ADDENDUM

PROJECT: Wayne State College **PROJECT NO.:** 19024
Campus Monument Sign

FROM: BVH Architecture **ADDENDUM NO.:** #1

WSC CAMPUS MONUMENT SIGN

1 ARCHITECTURAL SITE PLAN
1" = 20'-0"

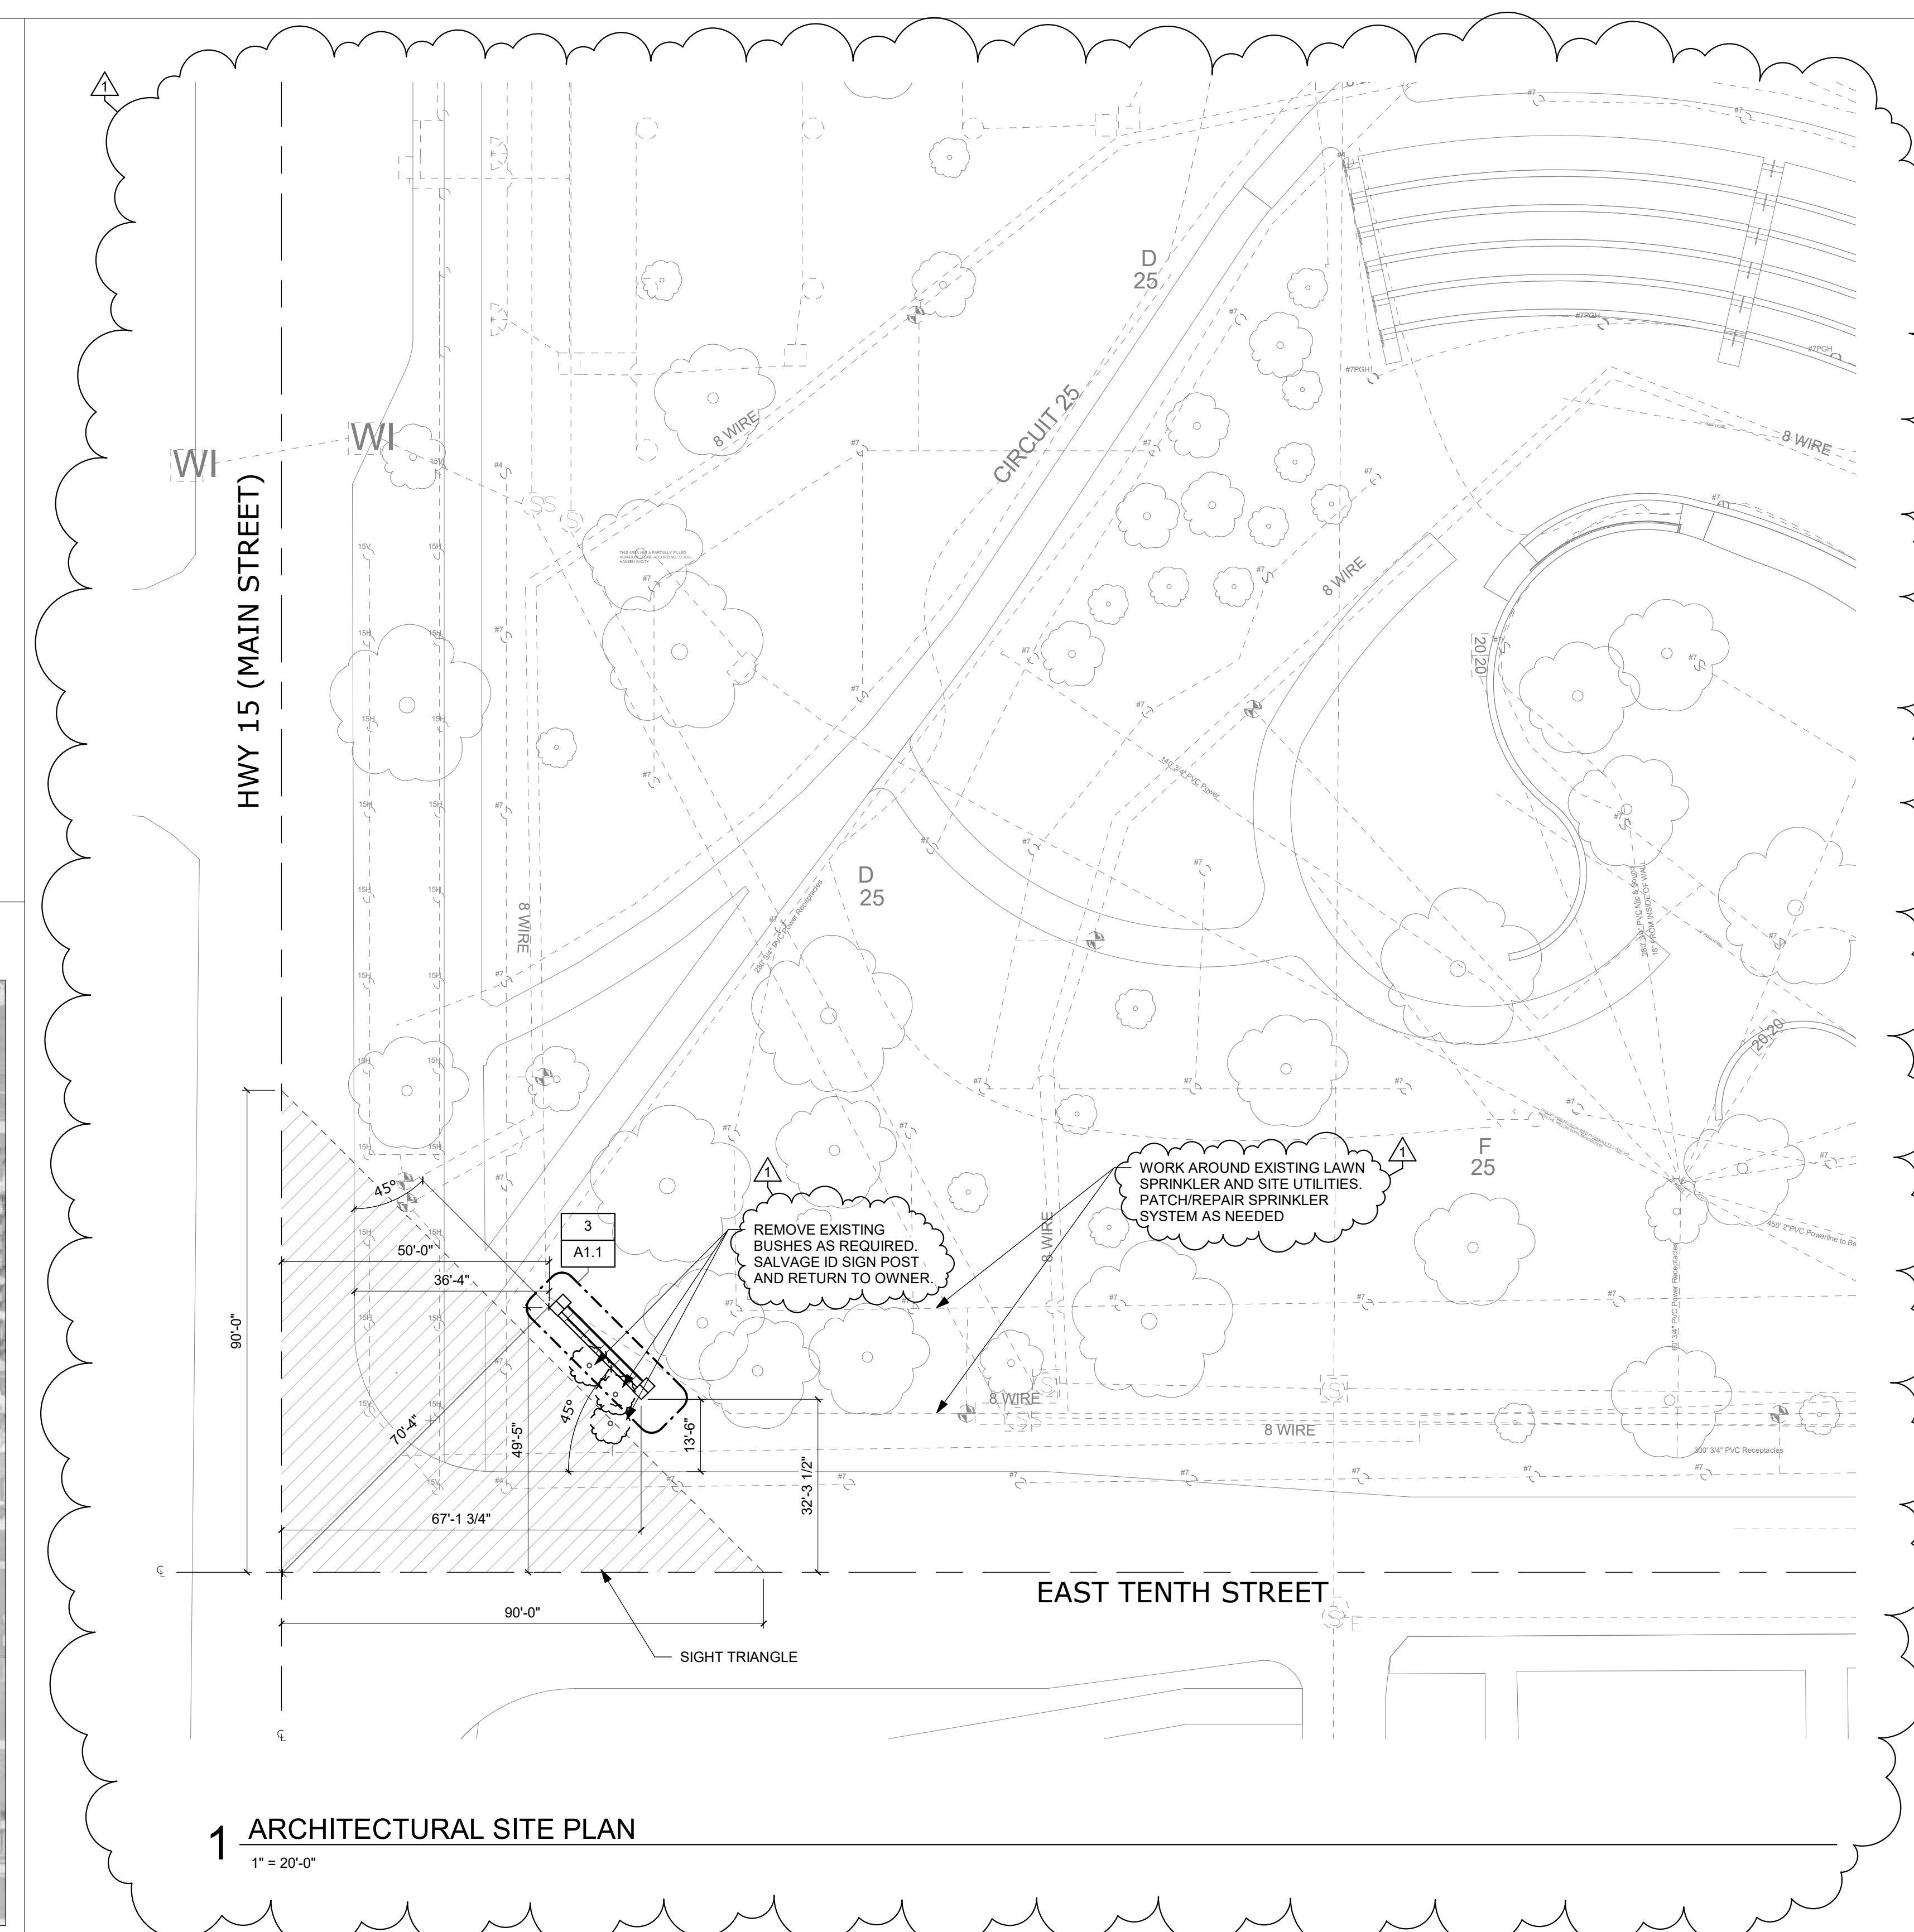
1. A0.1 - COVER SHEET AND SITE PLAN
 - a. Detail 1 - Architectural Site Plan.
 - i. Added existing site utilities to Architectural Site Plan. General contractor is responsible for field verifying existing site utilities. General contractor is responsible for working around existing site utilities. General contractor is responsible for patching/repairing lawn sprinkler system as needed.
 - ii. Salvage ID Sign Post and return to owner.
2. SE1.0 - ELECTRICAL SITE PLANS
 - a. The existing exterior panel is a 20 circuit breaker panel, not 30 as indicated in sheet note 6, sheet SE1.0
 - b. The circuit directory in the existing exterior panel is not accurate. Utilize spare breaker 13 to serve the monument sign and replace breaker 15 with a GFCI breaker to serve the receptacle at the sign.
